Modification of Development Consent

Application No:	SSD 7075
Applicant:	Cleanaway Pty Ltd
Consent Authority:	Minister for Planning
Development:	Erskine Park Waste and Resource Management Facility Staged Development Application, comprising: <ul style="list-style-type: none">• A concept proposal for a Waste and Resource Management Facility (WRMF) with a maximum processing capacity of 300,000 tpa. All waste received at the WRMF shall enter the Waste Transfer Station (Stage 1), up to 150,000 tpa of this waste may be recycled at the Resource Recovery Facility (Stage 2).• Construction and operation of the Stage 1 Waste Transfer Station with a maximum processing capacity of 300,000 tpa.
Date of Original Consent:	4 October 2016
Modification:	SSD 7075 MOD 1 – Modifications to the development staging, car and truck parking, the office, the load-out bays, the stormwater management system, site levels and landfill ramps.

ASSESSMENT REPORT

Section 96(1A) Modification Erskine Park Waste and Resource Management Facility (SSD 7075 MOD 1)

APPENDIX 1A – STAGE 1 AND 2 CONCEPT PROPOSAL

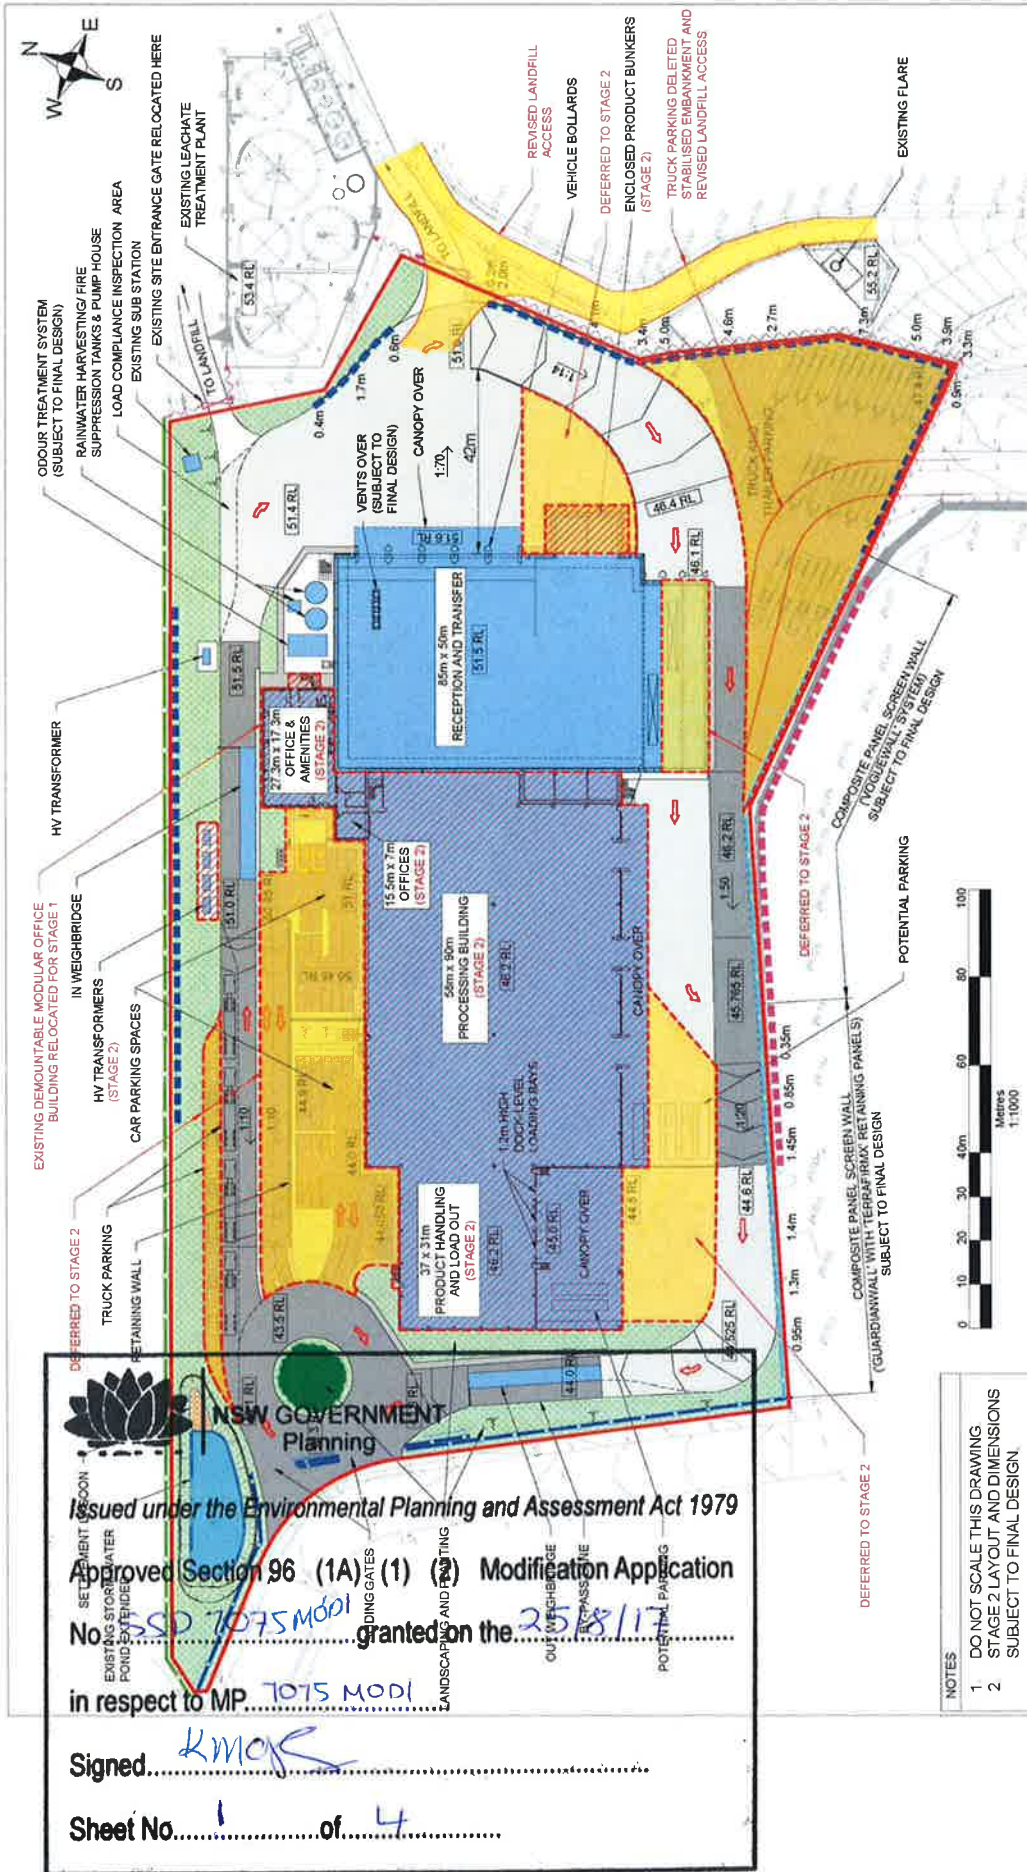
7. Replace Appendix 1 with new Appendix 1A and Appendix 1B.
8. Replace Appendix 2 with new Appendix 2.

- A1. Consent is granted to the Concept Proposal as described in:
- a) Schedule A;
 - b) Staged Development Application (SSD 7075);
 - c) EIS;
 - d) RTS;
 - e) Site layout plan as identified in Appendix 1A;
 - f) MOD 1; and
 - g) conditions contained in this development consent.

Figure 4: Proposed Stage 1 DA

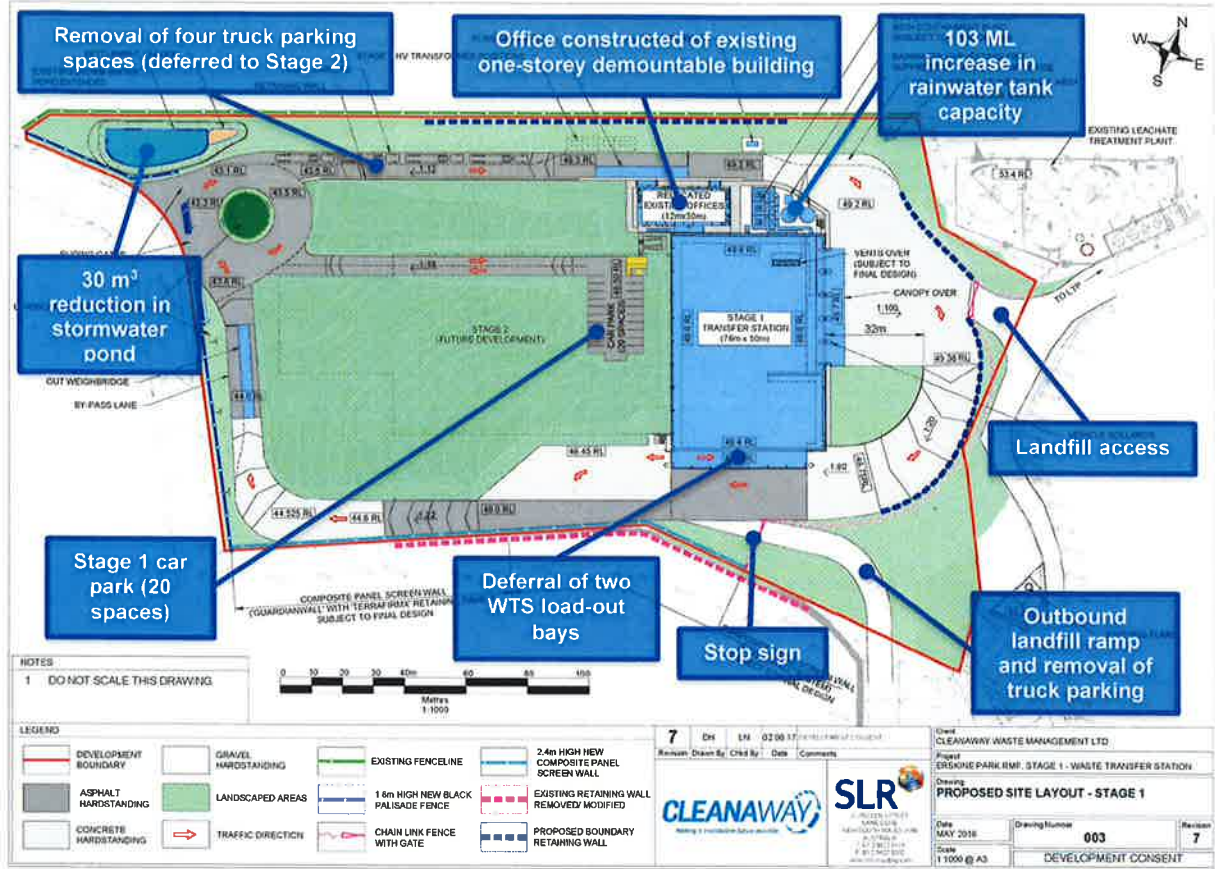
- changes to the site levels and a reduction of the amount of bulk earthworks across the site;
- deferral of the construction of the car park from Stage 1 to Stage 2, and the construction of an interim car park for Stage 1;
- deferral of the construction of the site office from Stage 1 to Stage 2 (existing demountable buildings currently owned and utilised by the Applicant for the existing adjacent landfill will be used for Stage 1);
- removal of the south-east truck parking and replacement with a landscaped area;
- construction of two additional landfill exit ramps;
- deferral of the construction of two load out bays in the WTS to Stage 2; and
- reduce the capacity of the stormwater detention basin;

Aspect	Approved	Proposed Modification
Car parking	<ul style="list-style-type: none"> • Stage 1 car park with 10 parking spaces over an area of 925 m² with a 5.5 m retaining wall. 	<ul style="list-style-type: none"> • An overall increase in car parking to facilitate the continued operation of the adjacent landfill and ensure all staff and visitors park on-site. • Defer car park to Stage 2 and provide interim parking in the RRF footprint, resulting in:

Aspect	Approved	Proposed Modification
		<ul style="list-style-type: none"> - Stage 1 car park with 20 spaces (+10) over an area of 580 m² (-345 m²); and - Stage 2 car park with 55 spaces (+45) over an area of 1,560 m² (+635 m²) in a tiered layout. • The Stage 2 car park would replace the Stage 1 car park.
Truck parking	<ul style="list-style-type: none"> • Stage 1 truck parking for 24 parking spaces provided over two parking areas, being: <ul style="list-style-type: none"> - parallel truck parking area along the north-west site boundary; and - truck parking in the south-east corner of the site. 	<ul style="list-style-type: none"> • Reduce the provision of truck parking due to a decision to contract out pick up and deliveries. • Removal of the south-east truck parking and replacement with a landscaped area and landfill exit ramp. • Seven truck parking spaces (-17) provided along the north-west site boundary over two stages, being: <ul style="list-style-type: none"> - Stage 1 truck parking with four spaces; and - Stage 2 truck parking for an additional three spaces.
